ST. PHILLIP CATHOLIC CHURCH PARISH HALL

SUMMARY

<p>Owner Diocese of Orlando</p> <p>Applicant Tyler Fitzgerald, CPH Engineering</p> <p>Project Planner Laura Eng, Planner II</p> <p>Updated: December 10, 2025</p>	<p>Property Location: Address (PID: 11-22-29-3056-07-170; 410; 390; 380; 360; 130; 141; 160; 180; 190; 200; 220; 240) or generally west of Backspin Ln, north of W Par St, south of Dubsdread Cir. (±6 acres, District 3).</p> <p>Applicant's Request: The site is developed with a ±18,940 sq. ft. church, eleven single-family residences and associated parking lots.</p> <p>The applicant is requesting a Conditional Use Permit (CUP) to expand the existing church with:</p> <ul style="list-style-type: none"> • A two-story, +23,486 sq. ft. Parish Hall • Expansion of the existing parking lot • A new (±3,800 sq. ft.) single-story priest residence to replace an existing residence • A wet detention pond with a dock feature. <p>Per Sec. 58.811 of the Land Development Code,</p>	<p>Assembly Public Benefit Use (community facility type) are conditionally permitted in the R-1 and R-1A zoning district.</p> <p>Staff's Recommendation: Approval of the request, subject to the conditions in this report

SITE & LANDSCAPE PLAN

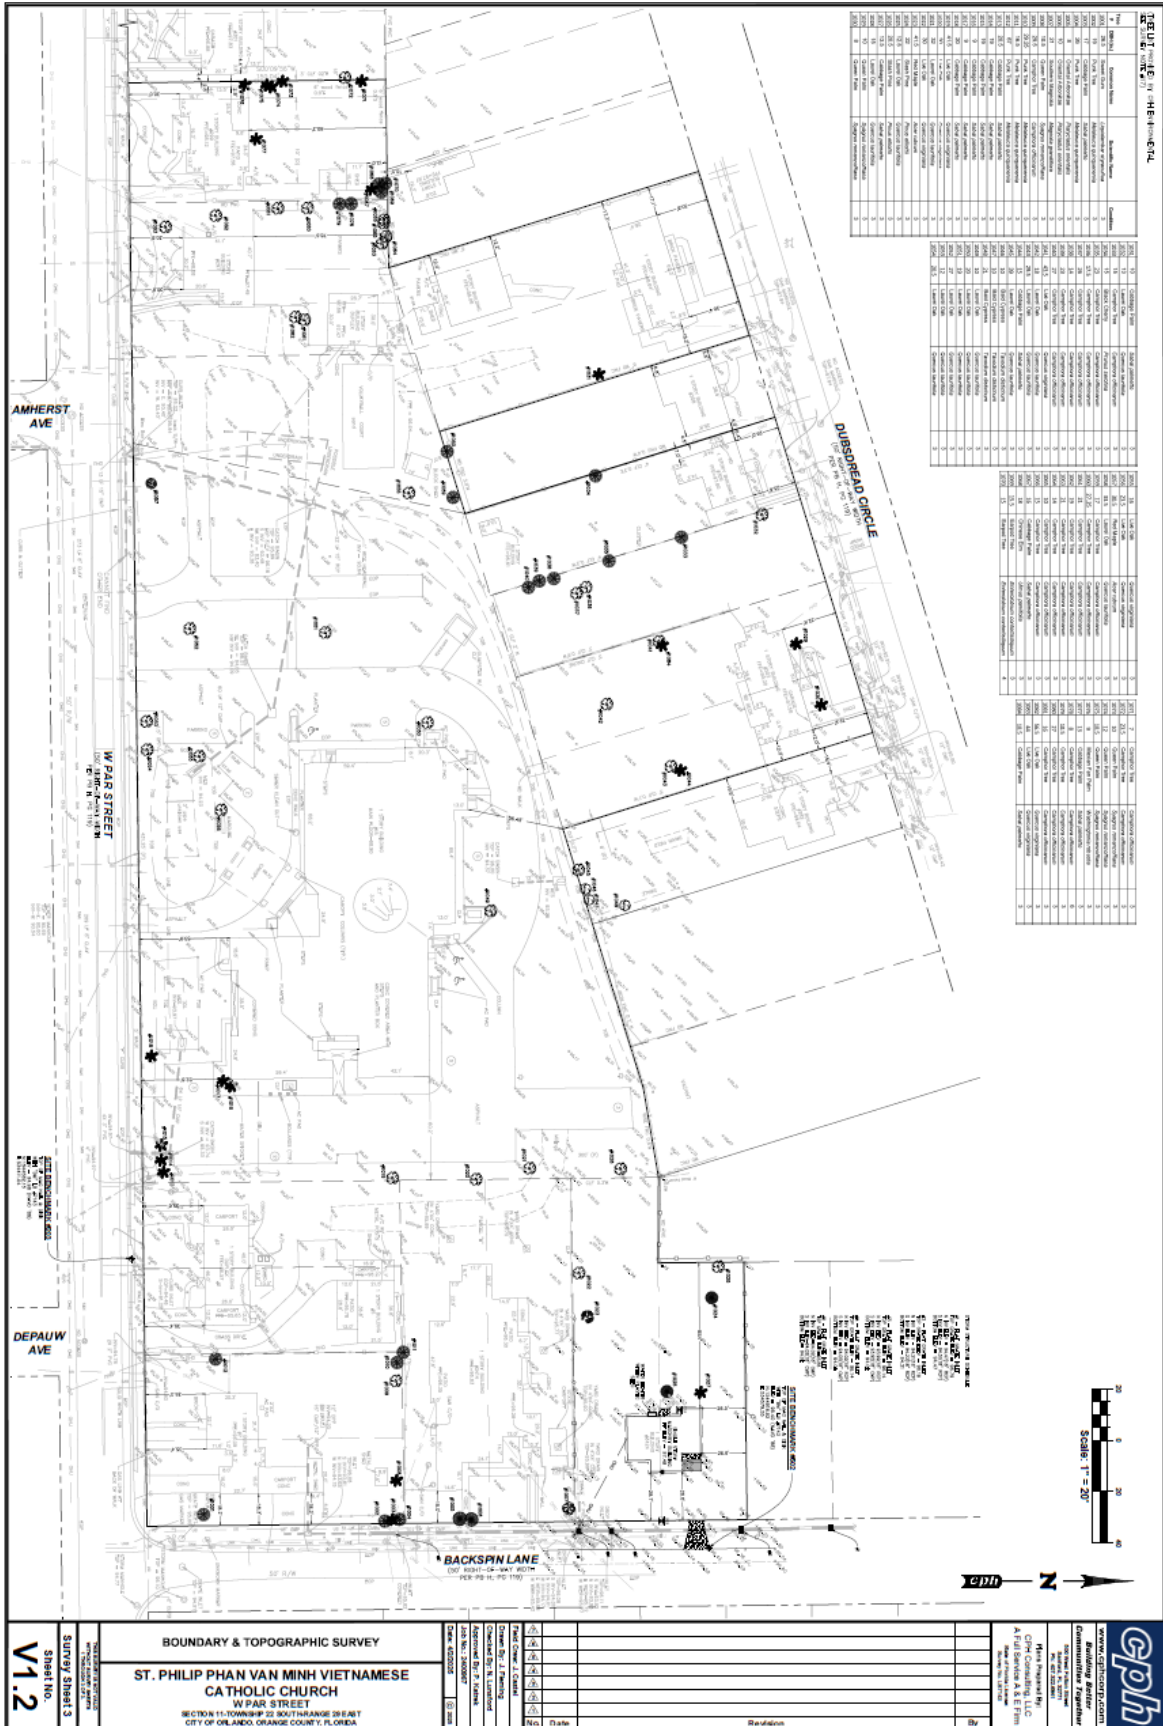
Currently, the applicant is proposing an emergency-access-only connection to Backspin Lane; however, the Transportation Planning Department does not support this proposed access. Operationally, the site can function adequately with circulation to and from W. Par Street. Therefore, the Department’s recommendation of approval is conditioned upon the applicant removing this access from the site plan.

Another condition requires the applicant to relocate the loading and unloading area, as the current location does not comply with the Land Development Code regarding parking dimensions and turning movements. Lastly, the grass parking area located in the northeast portion of the site must include appropriate signage to inform drivers about the one-way loop in that area.

- b. At the final site plan determination, the applicant must remove the full-access connection to Backspin Lane. The Department is conditioning the CUP on all access being through W. Par Street. Additionally, the applicant, where applicable, must reconfigure the orientation of the driveways, operational flow, and auto-turns to demonstrate compliance with the Land Development Code in providing access to and from W. Par Street.

- c. At the time of the final site plan determination, the applicant must adequately identify and relocate the loading and unloading area. The area currently proposed in this site plan is neither supported by the Transportation Department nor in compliance with the Land Development Code. Please refer to Conditions #5-5.2.

e. Any proposed work within the right-of-way along Backspin Lane must be approved by both the Transportation Planning Department and the Department of Public Works. As proposed, the site plan shows an altered and sharper turning radius for vehicles making a right turn while traveling southbound on this road.

- f. At the time of permitting, the northeast grass parking area must include signage to alert entering traffic that the parking area operates as a one-way loop.
